RPZ Consultation 2022 Amendment Report for Formal TRO Consultation Walcot, Snow Hill and Claremont Road area

(Walcot and Lambridge Wards, Bath)
An area originally including Snow Hill and adjoining roads, stretching north to include Bennet Lane, Arundel Road and part of Camden Road; east to Eastbourne Avenue, Claremont Road and St Saviours Road; south to Kensington Place and the boundary of the River Avon; and west to parts of the The Paragon, London Street and London Road.

Bath and North East Somerset Council

15th August 2022

Figure 2: Bay amended to dual-use adjacent to health centre on Tyning Lane

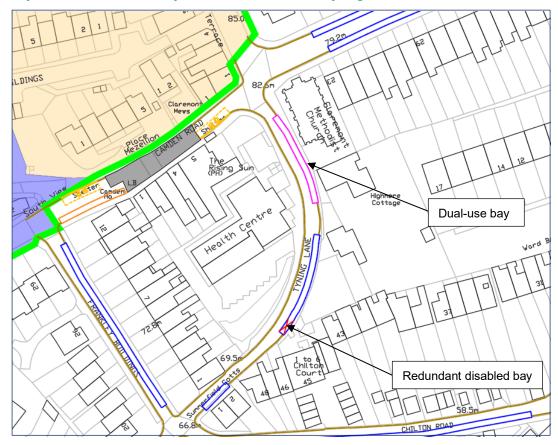
1) The ward councillors suggested that there may be a requirement to provide some dual-use parking provision in the vicinity of the health centre off Tyning Lane.

Figure 3: Arundel Road and Highbury Place to be signed as permit parking areas

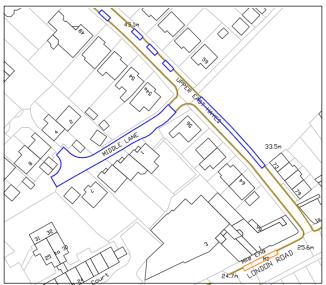
- 5) Arundel Road: Residents responding to the consultation have requested that Arundel Road be signed as a permit-parking area. In order for adjacent roads to be treated similarly, Highbury Place should be signed as a permit-parking area, with a sign installed east of its junction with Bennett Lane.
- 6) Middle Lane. Residents responding to the consultation have requested that Middle Lane be signed as a permit-parking area with a sign installed west of its junction with Upper East Hayes.
